## 3803 SOUTH WARSAW STREET

SDCI #3037570  
EDG-2 06.17.2021

PREPARED BY: KÖZ DEVELOPMENT

EDG1 - PUBLIC COMMENT

COMPOSITE SITE PLAN

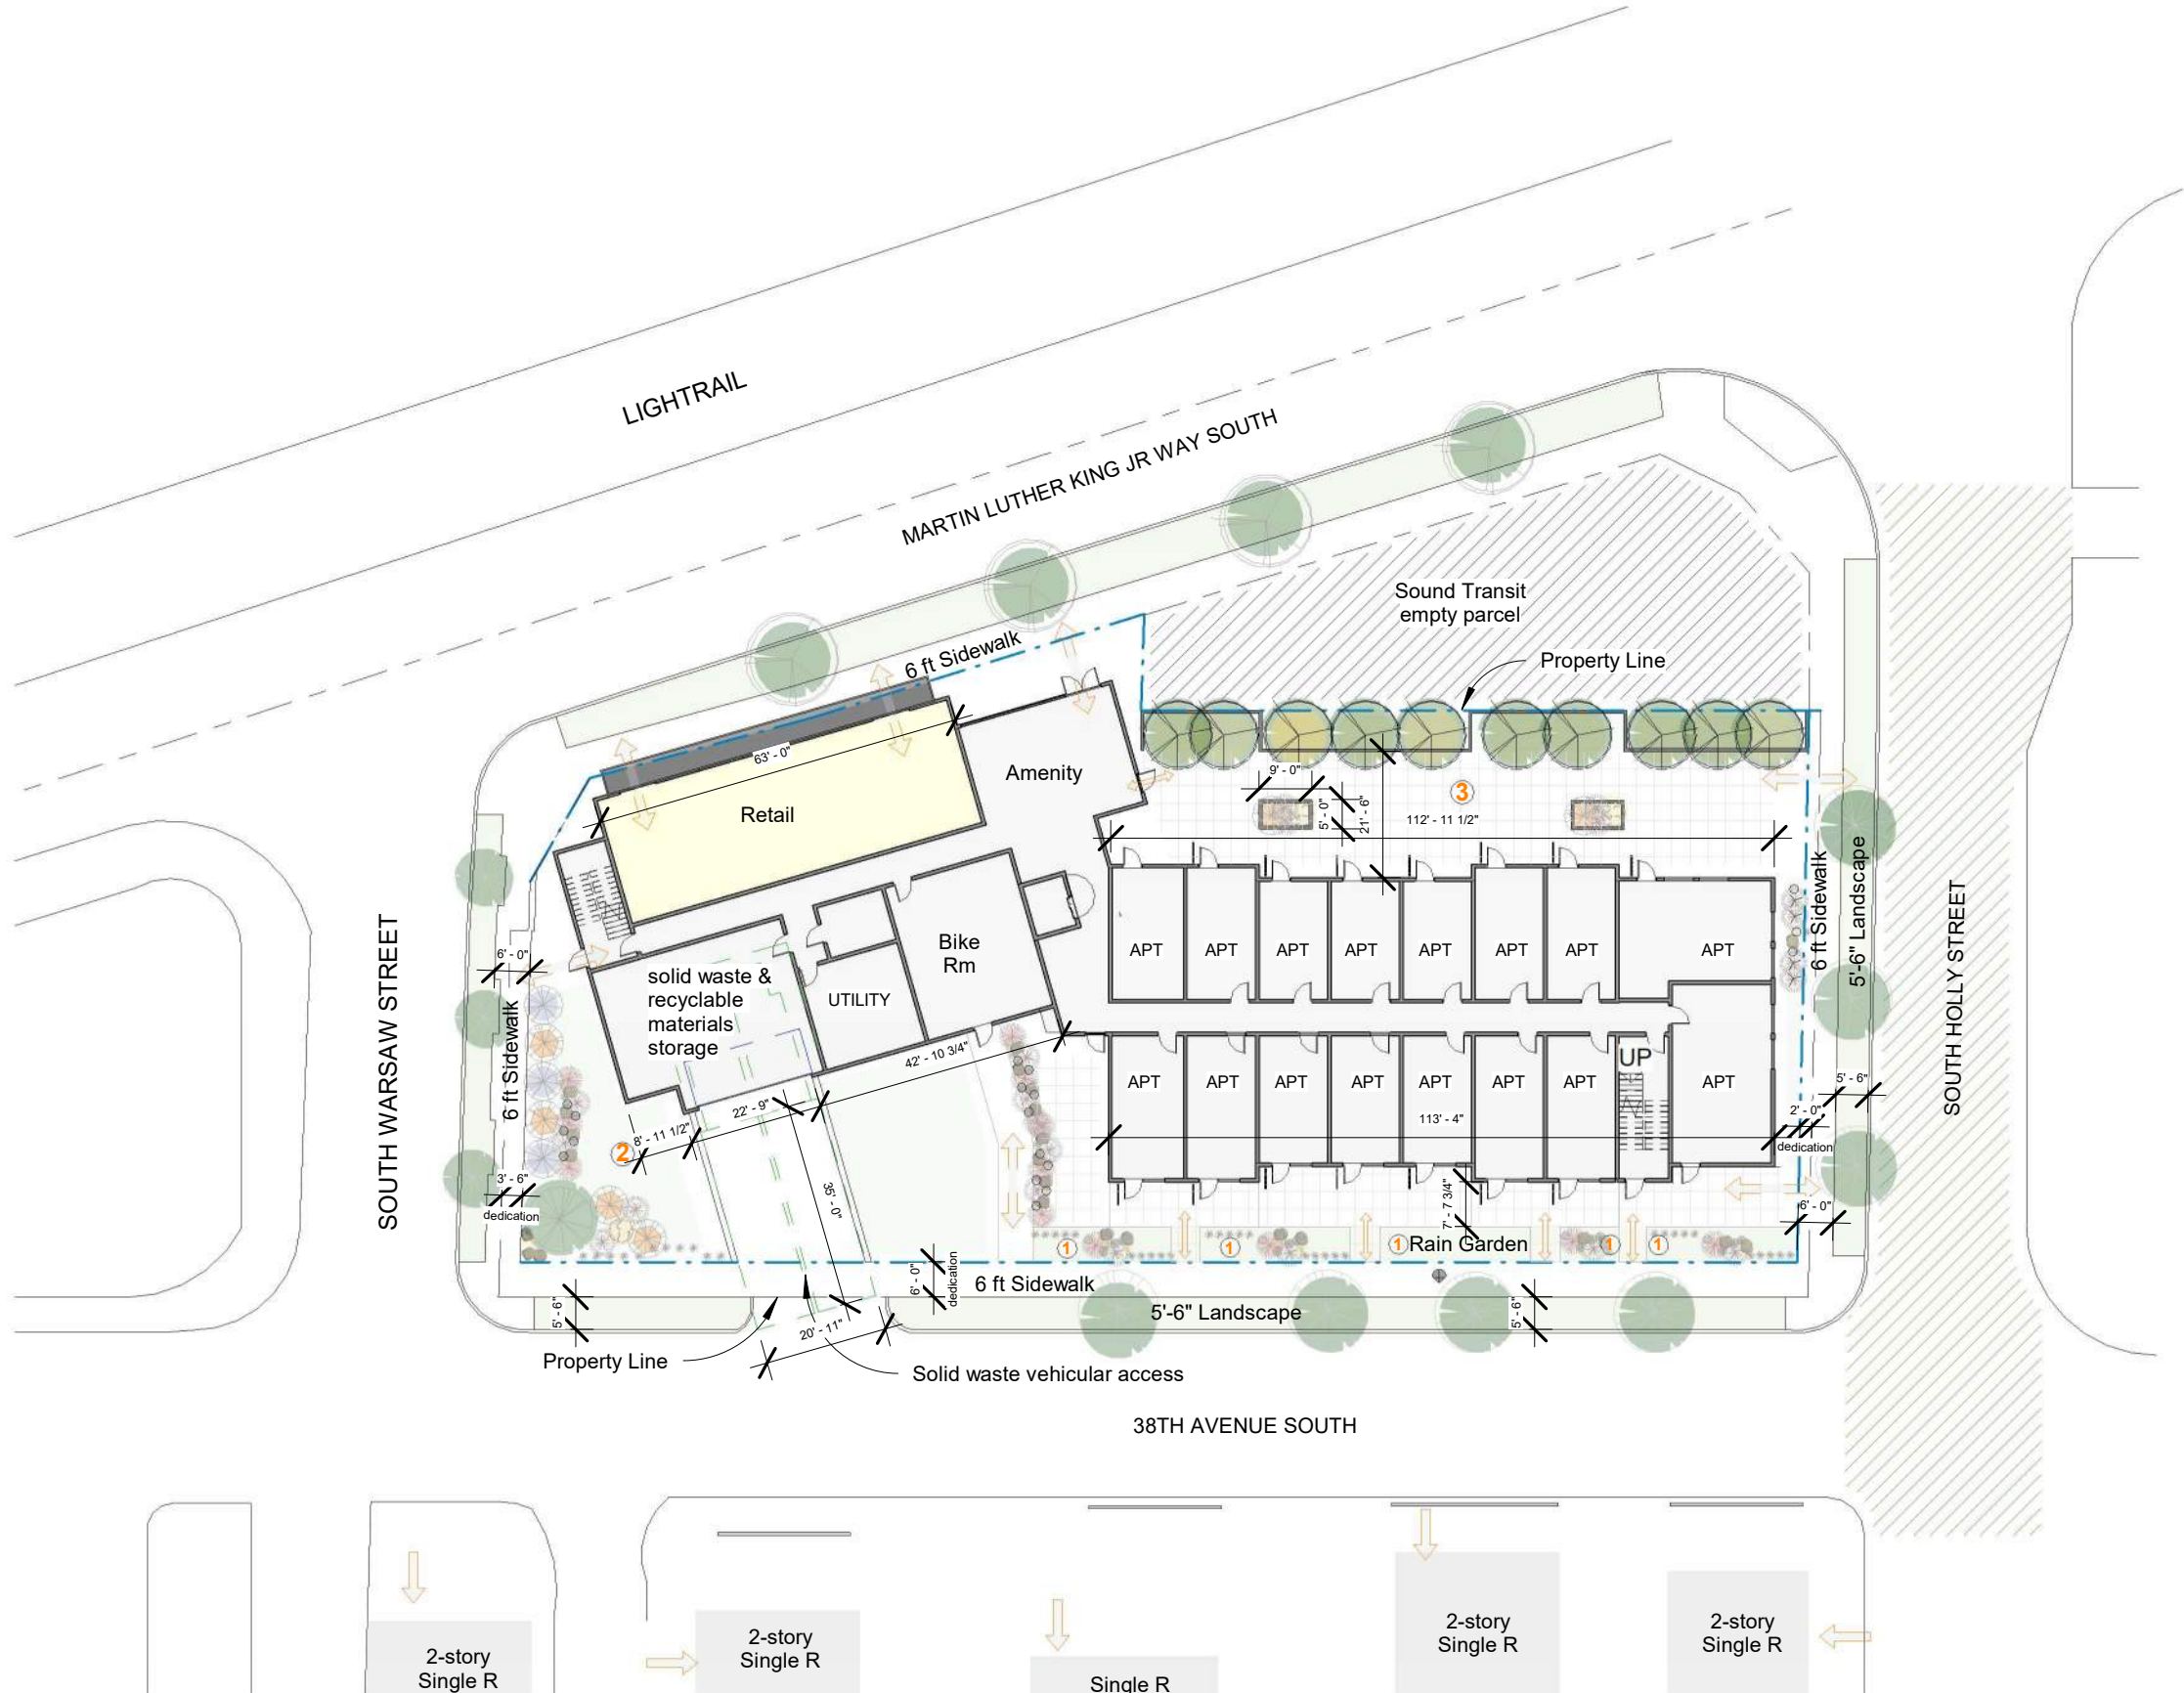
2. **Study the context's surrounding street edge condition to assist in determining what is the appropriate street wall or plaza condition. How will this project fit into the larger context? (DC2-A-1. Site Characteristics and Uses)** A further study of the larger street context and the project's masses helped shape the site and landscape design. See Composite Site plan.

a. **Further consider the future greenway along South Holly St and how the proposed landscape plan will support and add to the greenway. (PL1-A-2. Adding to Public Life, PL1-B Walkways and Connections)**

b. **Provide a composite landscape plan / first floor plan which clarifies entries, setbacks, occupiable vs. passive spaces, and circulation.(DC4-D Trees, Landscape, and Hardscape Materials, DC3-A Building-Open Space Relationship)**

e. **Consider and explore how residential common entry and stoops could improve the residential character and scale along 38th Ave S. (PL3-A Entries, PL3-B Residential Edges)**

See the composite site plan and the conceptual landscape design

Please see composite siteplan

The composite site plan and inspiration design images provided in the design guidelines for the new design present the intent of the feel and look of the common residential entry and the entries of the individual units on the ground floor.
